UNITED STATES PATENT AND TRADEMARK OFFICE

10/695,038

Office Action Summary	Application No. 10/695,038	Applicant(s) JUSTIN ET AL.	
	Examiner JYOTI NAGPAUL	Art Unit 1797

DETAILED ACTION

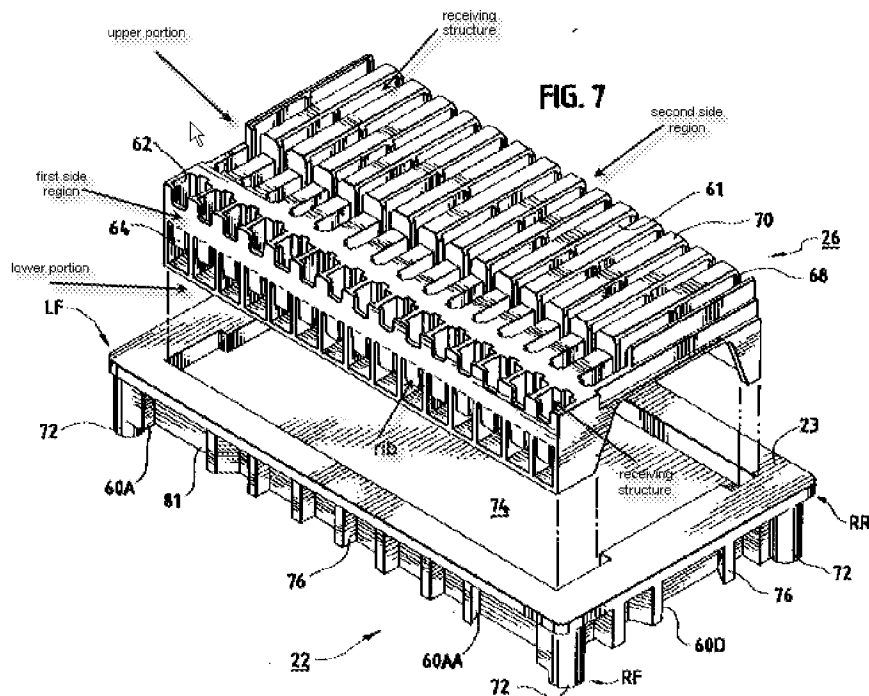
Fanning teaches a carrier for holding test samples comprising a body having an upper portion, a lower portion a lower surface and first and second side portions. The body further comprising a rib projecting from the lower surface placed between the first and second side regions. The carrier further comprises receiving structures in the upper portion for holding up to N test sample devices and up to N test tubes containing test samples, where N is an integer greater than 1. The carrier further comprising a portion comprising a handle and an opposite portion having a fiat panel for receiving a machine readable indicium. (See Figure below) The test sample devices comprise multi-well test sample cards (28).

Fanning fails to teach N optical interrupt positioning features comprising N voids formed in the rib projecting from the lower surface, each of the voids placed in registry with one of the receiving structures for detection of one of the positioning features by a fixed optical interrupt sensor in the sample testing instrument. Fanning further fails to teach the carrier comprises alphanumeric indicia for the receiving structures. (See Figure 7)

Stevens teaches an analytical instrument with two moving trains of sample holders. The sample holder comprises N optical interrupt positioning features comprising N voids formed in the rib (50). Each of the voids are placed in registry with one of the receiving structures (204) for detection of one of the positioning features by a fixed optical interrupt sensor in the sample testing instrument. (See Figure 7) The carrier further comprises alphanumeric indicia for the receiving structures.

It would have been obvious to one having ordinary skill in the art to provide the carrier of Fanning with N optical interrupt positioning features comprising N voids formed in the rib projecting from the lower surface, each of the voids placed in registry with one of the receiving structures for detection of one of the positioning features by a fixed optical interrupt sensor in the sample testing instrument to achieve the predictable results of performing the desired analysis of the sample when it passes through the optical sensor in the instrument. Therefore, minimizing or eliminating the attention of an operator and making the process fully automated.
